Village of Arlington Heights
Conceptual Plan Review Committee
Community Room, 3rd Floor
Arlington Heights Village Hall, 33 S. Arlington Heights Rd.
April 24, 2024
6:30 PM

VILLAGE OF ARLINGTON HEIGHTS
STAFF DEVELOPMENT
COMMITTEE REPORT

Temp File Number: T1838
Project Title: The Berkshire Senior Living Residence
Address: 8-12 S. Beverly Lane
PIN: 03-29-411-014

Temp File Number: T1837
Project Title: The Moorings Independent Living Expansion
Address: 800 E. Central Rd.
PIN: 08-10-113-002, -003, and -004

CONCEPT | PROPOSED PARKING GARAGE PLAN

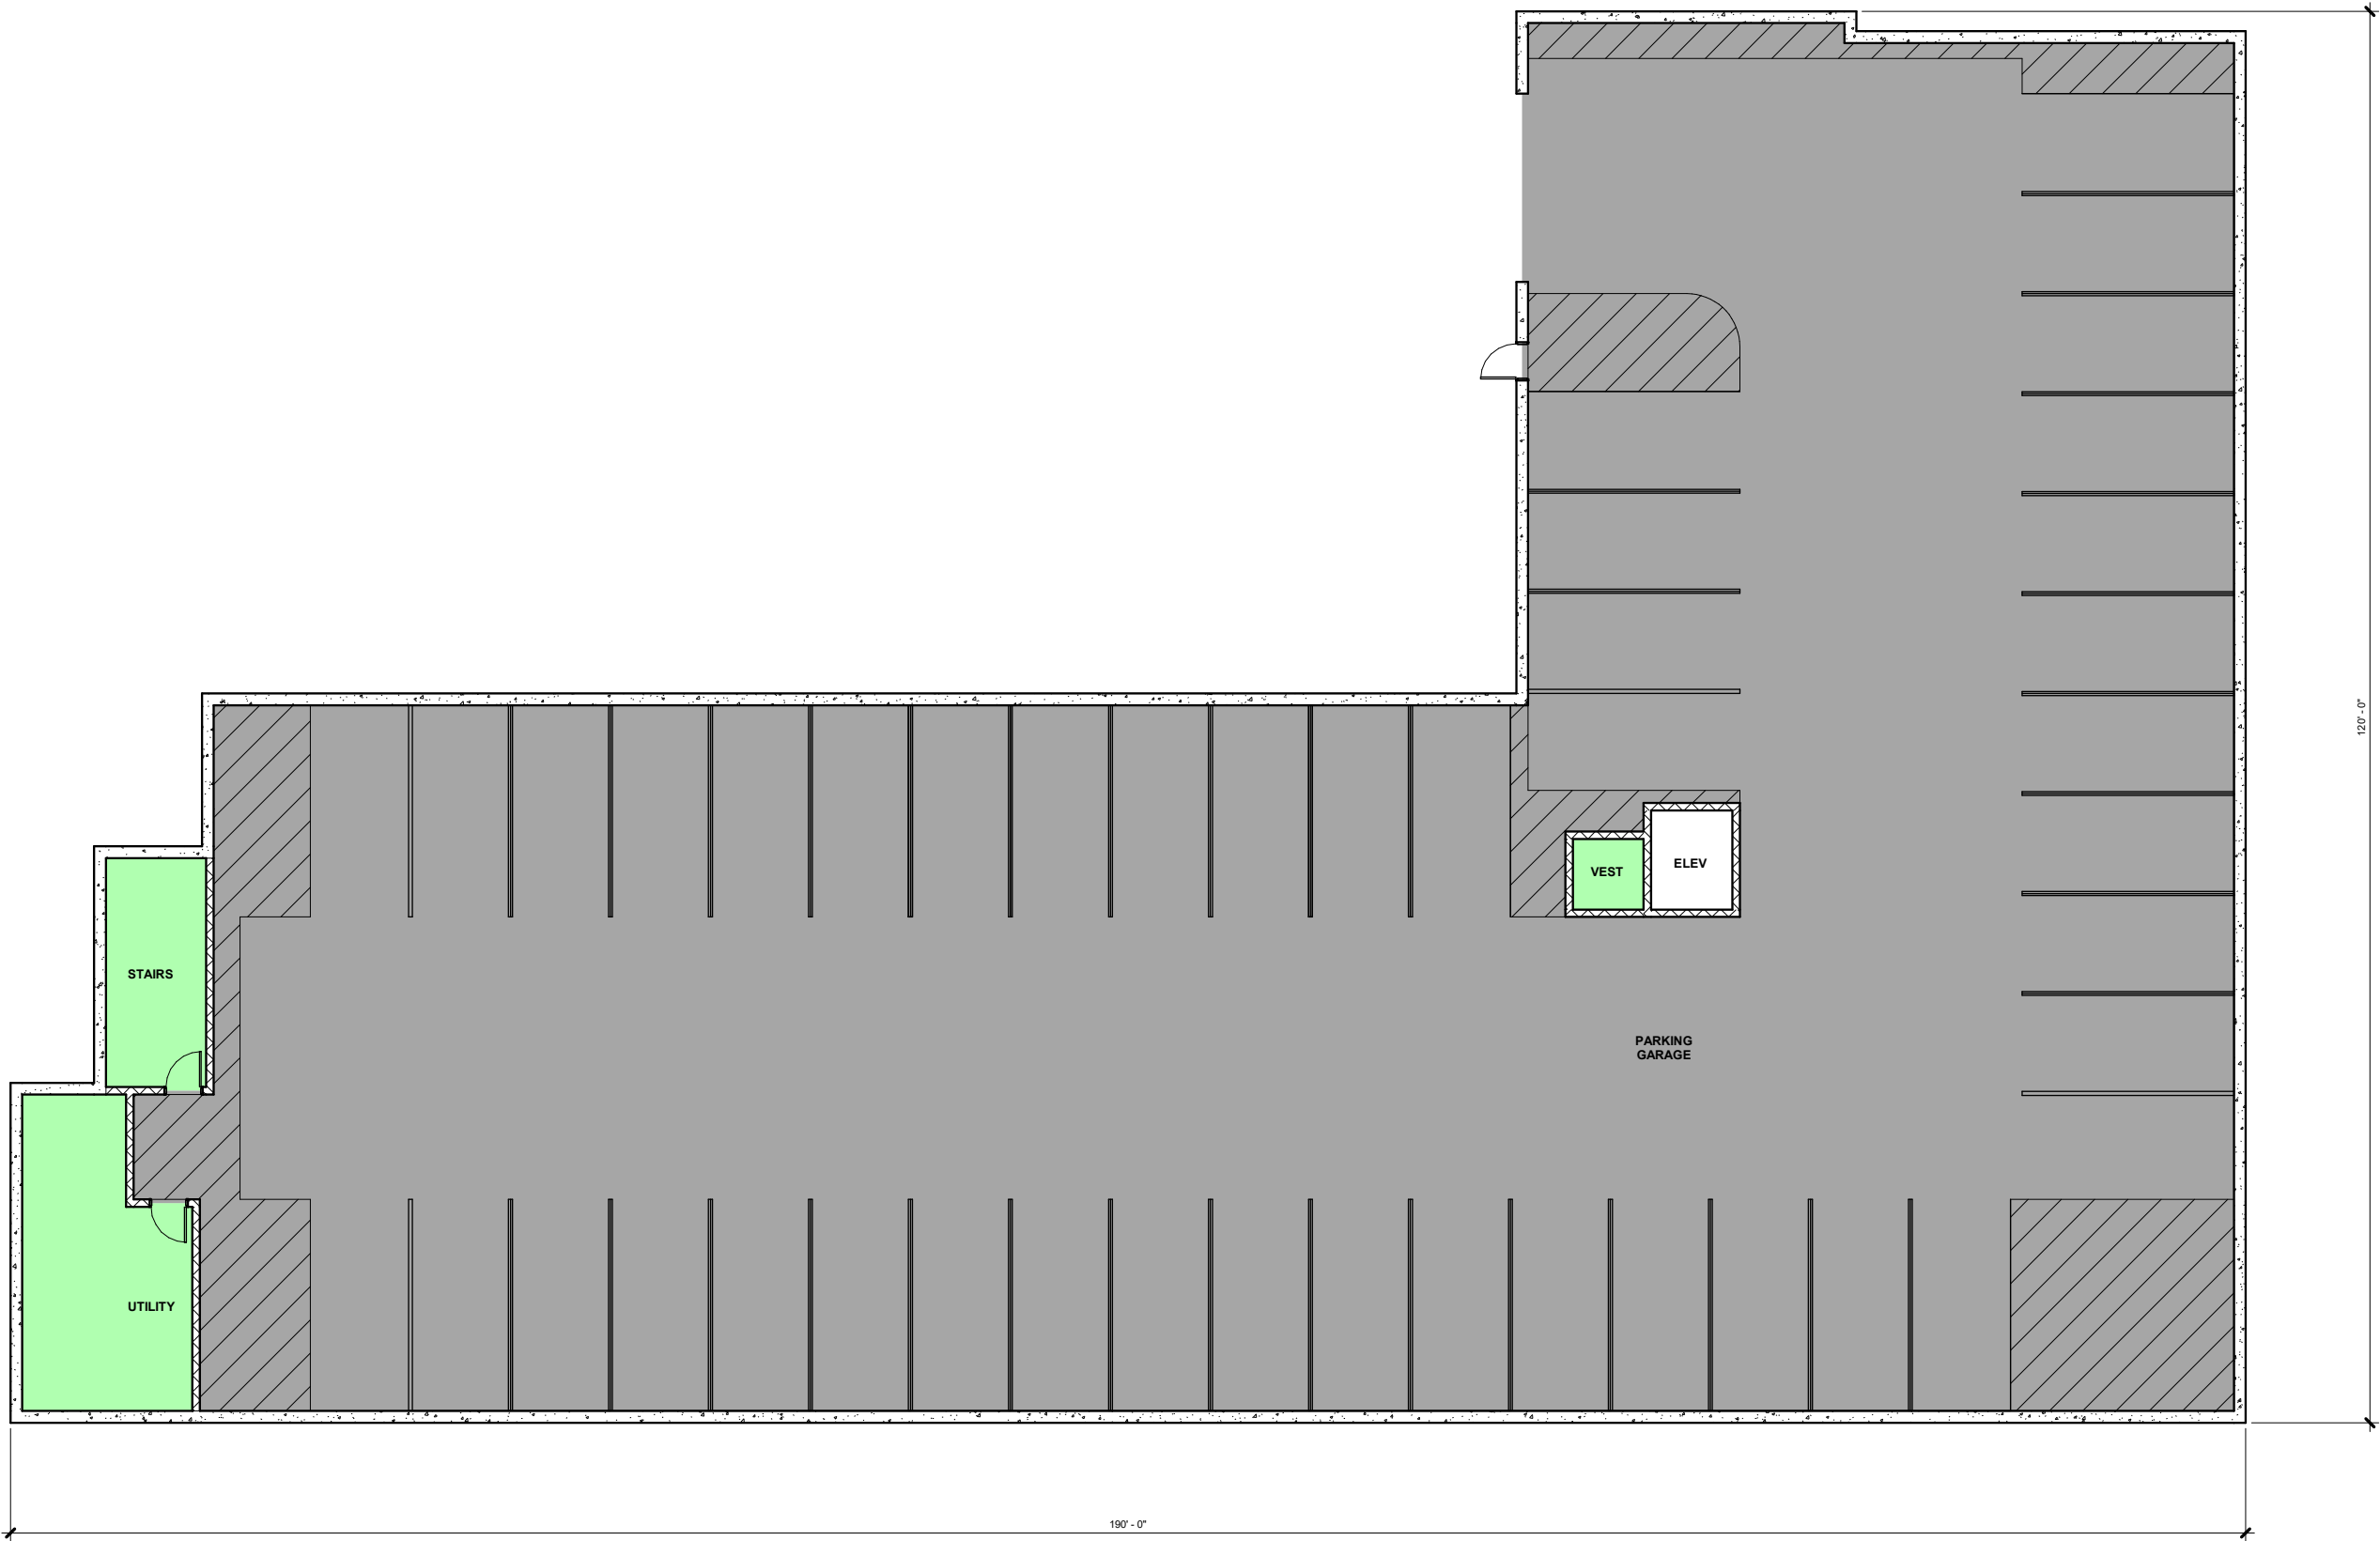
Per zoning requirements, the subject property must provide 66 parking spaces (1.5 per unit) based on the number of residential units (see Table I below). The subject property would include 52 parking spaces (1.18 per unit), which requires the following variation:

One 10' x 35' loading space for the development is required, and none is shown on the conceptual plans. The petitioner will need to clarify if they are requesting a variation to waive this requirement.

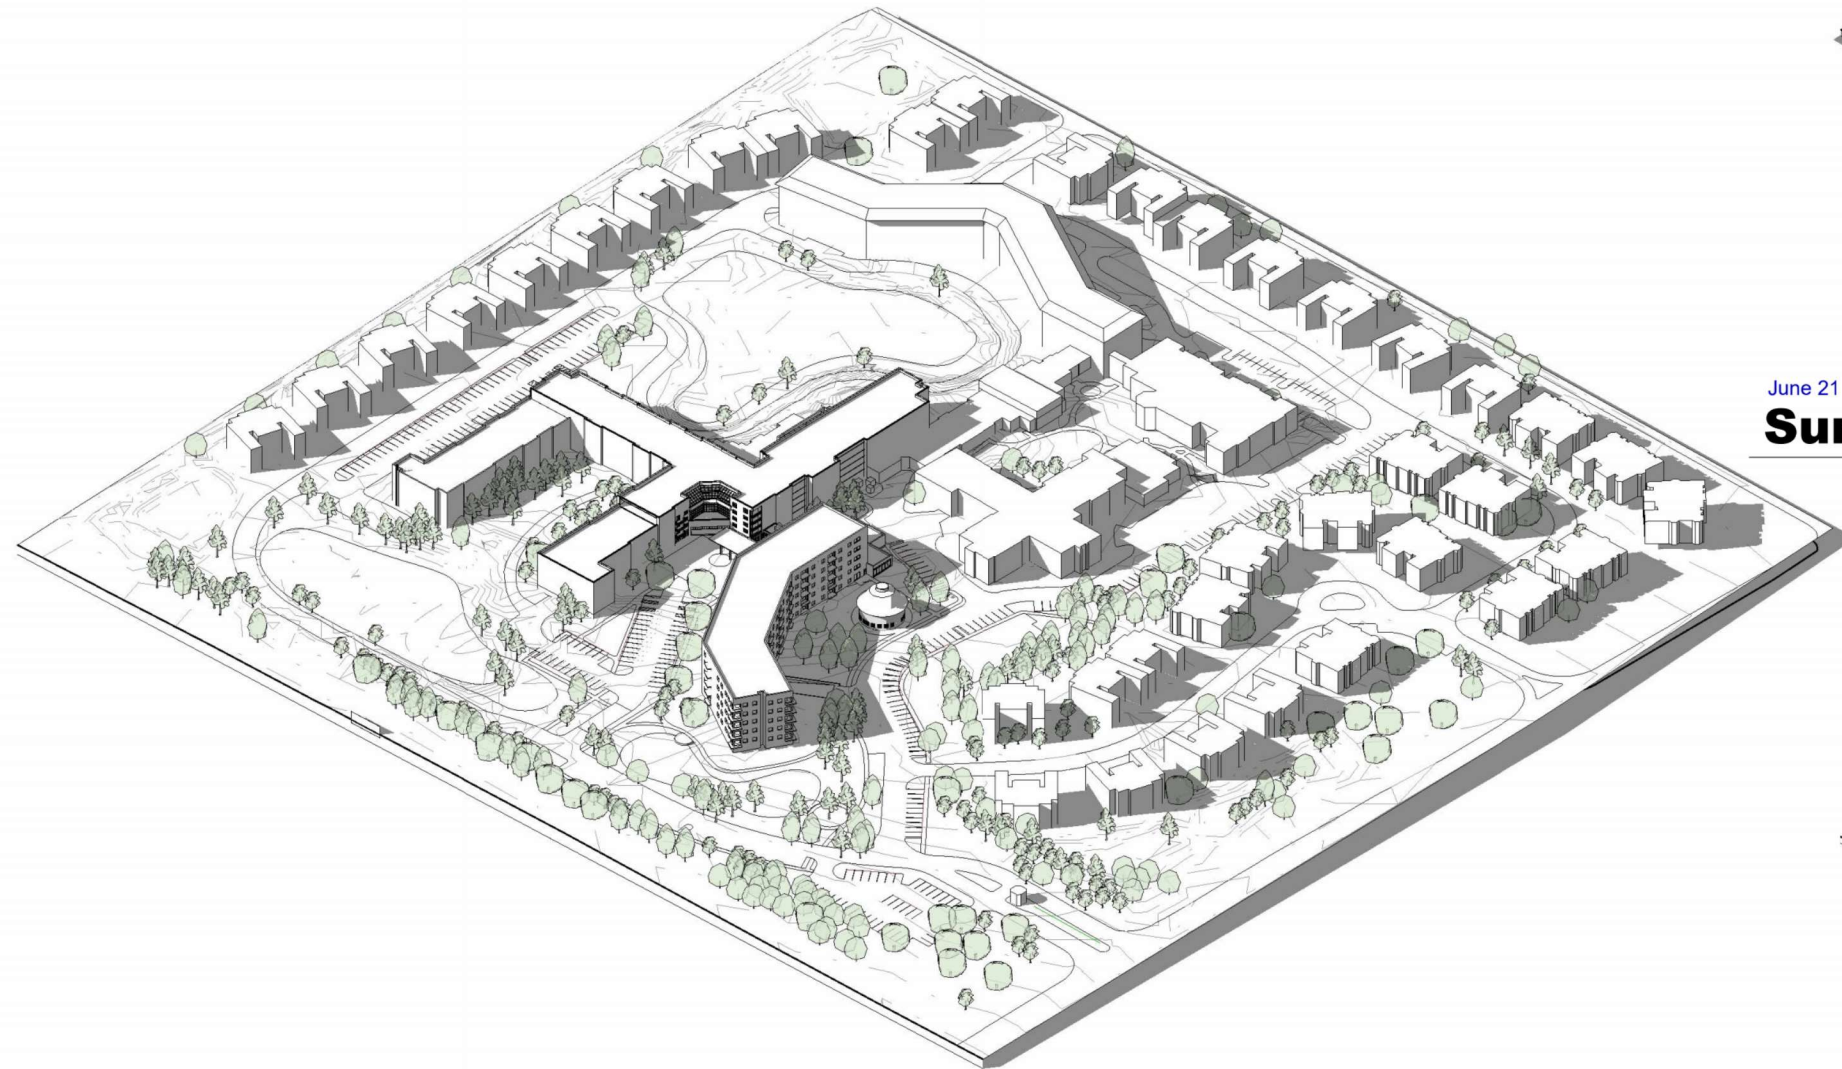
1. Variation to Chapter 28, Section 5.1-8.5, Maximum Height, to allow an approximately 65' tall five-story building where maximum building heights are restricted to 45' and four stories.
2. Additional variations may be required based upon the submittal of detailed plans.

The Moorings campus has previously been granted a height variation in 2015 to allow a four-story assisted living building addition at 48.5' in height, and also in 1985 to allow construction of 5-story buildings with average heights of 49.5'. The newly proposed independent living building would be located towards the center of the site and setback approximately 187' from the nearest property line to the east, which abuts single-family homes. The petitioner must provide a written justification outlining how the requested height variation conforms to the four approval criteria as summarized below:
